Preliminary Project Assessment

Date: Thursday, July 14, 2016
Case No.: **2015-014028PPA**
Project Address: 3333 California Street
Block/Lot: 1032/003
Zoning: RM-1 (Residential, Low-Density)
40-X
Project Sponsor: Don Bragg c/o Prado Group
150 Post Street, Suite 320
San Francisco, CA 94108
415-857-9324
Staff Contact: Brittany Bendix – 415-575-9114
Brittany.bendix@sfgov.org

Title: 3333 California Street - 2015-014028PPA

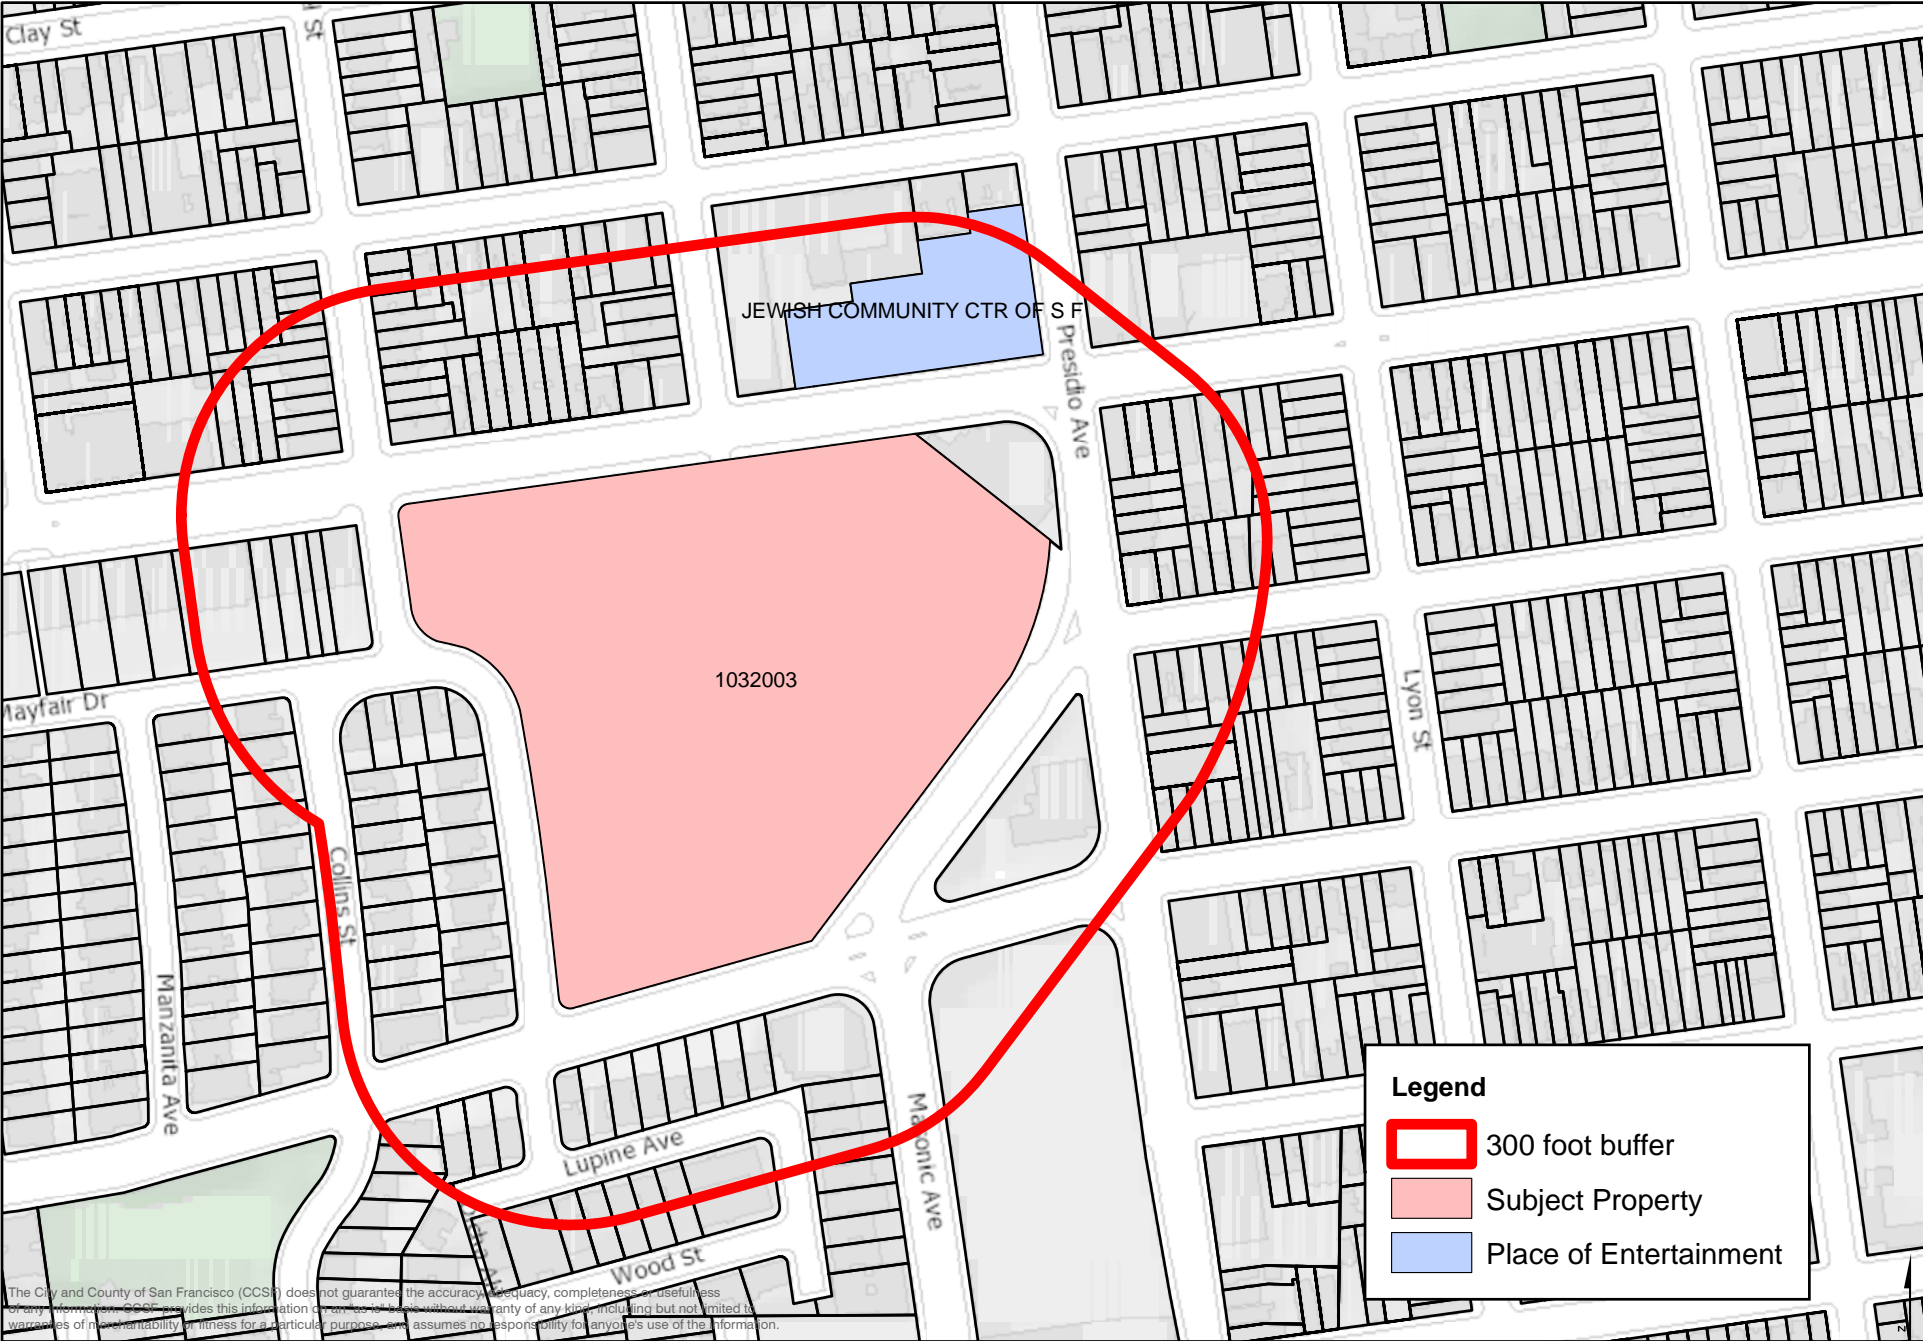
5. A **Shadow Analysis** is required under Planning Code Section 295 as the project proposes building heights in excess of 40 feet, as measured by the Planning Code. A shadow analysis, attached, indicates that the project may cast new shadow on Laurel Hill Playground, which is under the jurisdiction of the Recreation and Parks Department. As a result the project requires that a shadow analysis must be performed per Planning Code Section 295. Please note that this preliminary analysis reflects the maximum building height (plus mechanical features) as applied to the entire lot.

Comments: Building height modeled at 100 feet at full extent of property.
Slopes taken into account.
